Tennessee Valley Authority, 1101 Market Street, Chattanooga, TN 37402

CNL-17-118

Clinch River Nuclear Site
NRC Docket No. 52-047

Subject: Supplemental Information Related to Environmental Report Figures in Support of
Early Site Permit Application for Clinch River Nuclear Site

Figure 2.4.1-1. Land Cover Types on the CRN Site

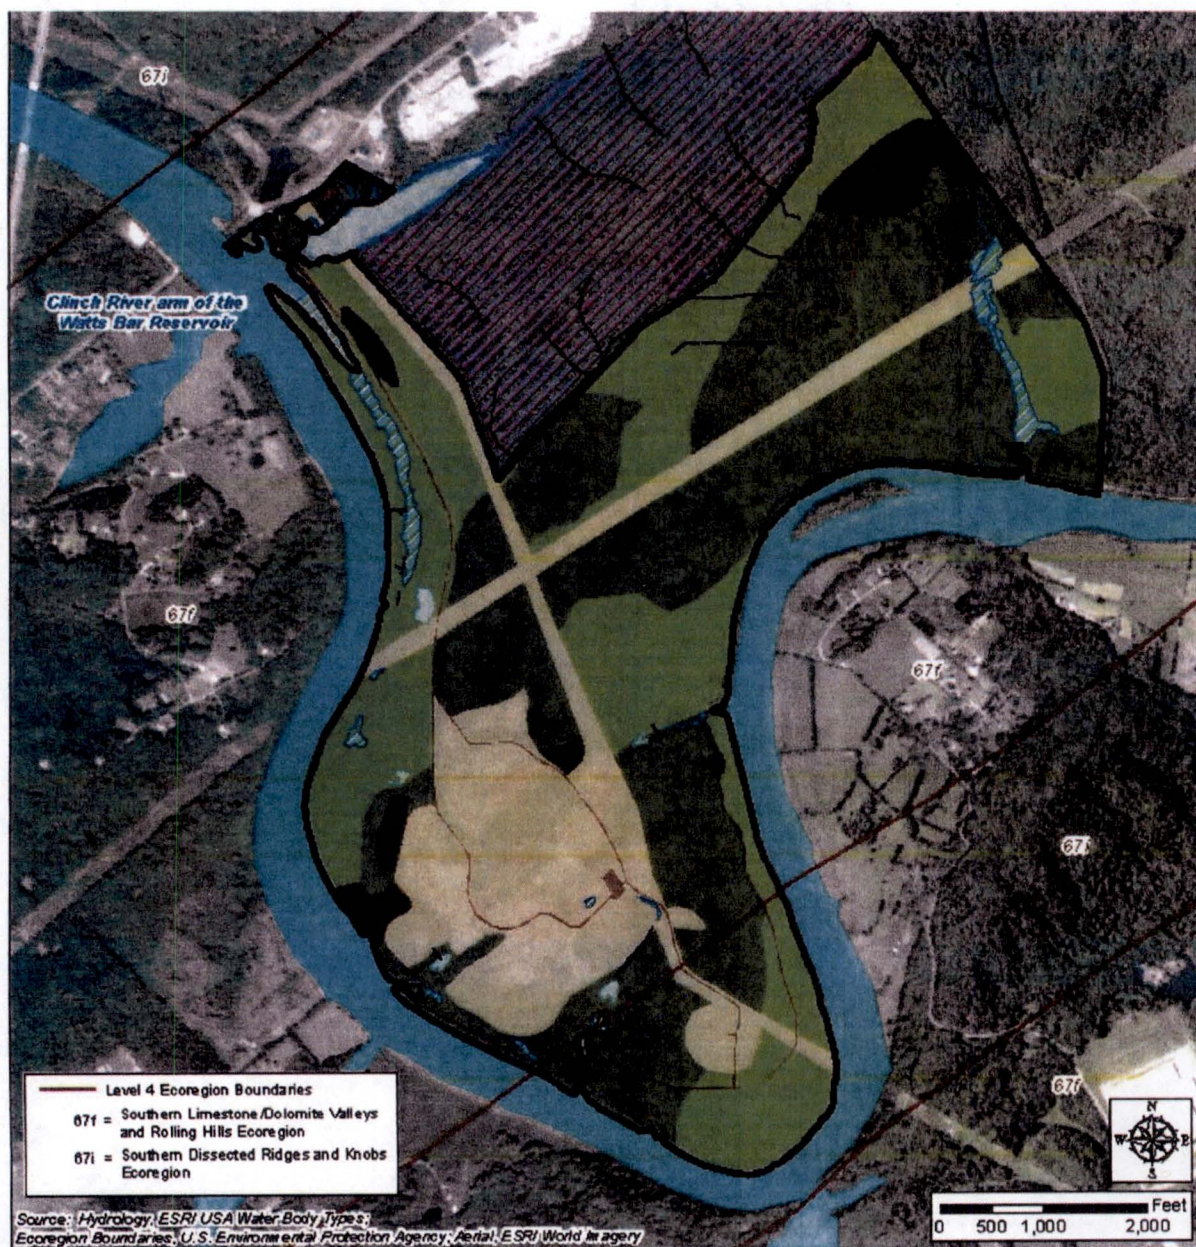
During the public meeting held on August 14, 2017, the NRC staff requested clarification of the source data used in the development of ER Figures 2.4.1-1 and 4.3-1.

ER Figure 2.4.1-1 is being revised as indicated.

The source data used to inform ER Figures 2.4.1-1 and 4.3-1 were CRN Site and Barge/Traffic Area (BTA) field surveys conducted by TVA biologists to characterize vegetation communities, wetlands, and ponds. The findings from these surveys are described in ER Subsection 2.4.1.1, "Upland Habitats," and ER Subsection 2.4.1.2, "Wetland Habitats." Based on the interpretation of aerial imagery, in conjunction with the descriptions of vegetation communities, wetlands, and water bodies provided by these field surveys, dominant vegetation communities and other land cover types were delineated on aerial photographs by hand. This information was converted to Geographic Information Systems (GIS) layers and mapped using GIS to create ER Figures 2.4.1-1 and 4.3-1. Acreages for the land cover types were then calculated using the GIS polygons (shown in the figures). Acreages for the land cover types are summarized in ER Table 2.4.1-1. As noted in ER Table 2.4.1-1, wetland acreages were accounted for in the vegetation community type in which they occur (i.e., deciduous forest, mixed forest, or herbaceous).

ER Figures 2.4.1-1 and 4.3-1 are being revised to include the source data references. In addition, ER Table 2.4.1-1, Note 1 is being revised to reflect the method used to develop the land cover types.

Figure 4.3-1. Areas to be Cleared and Land Cover Disturbed on the CRN Site and Barge/Traffic Area

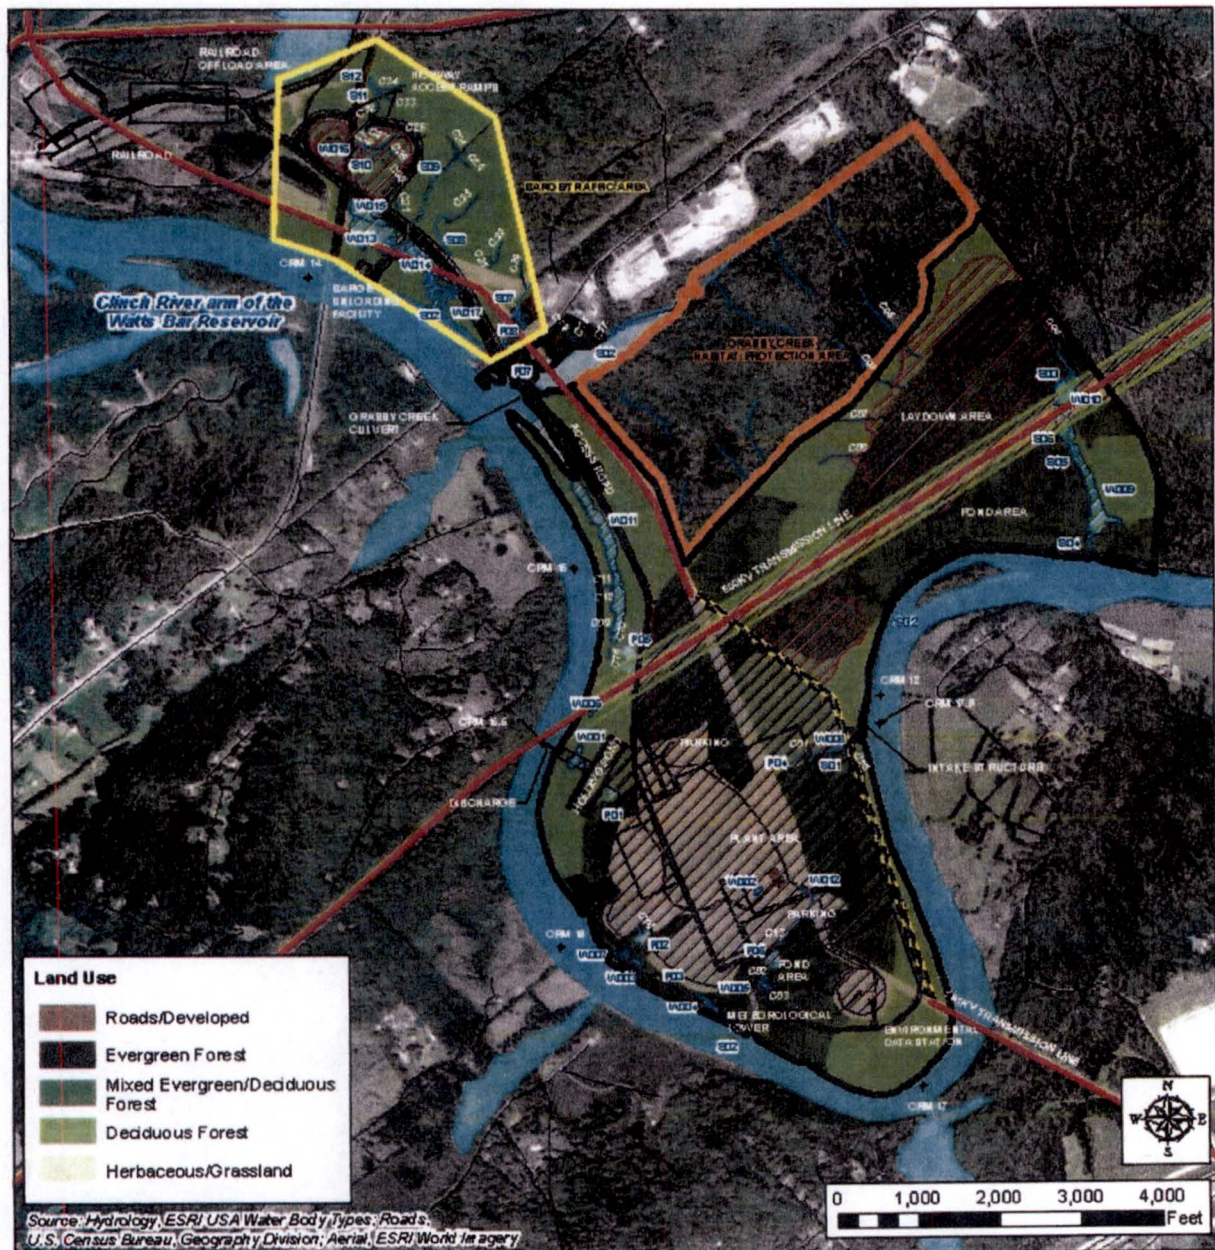
ER Figure 4.3-1 is being revised as indicated.
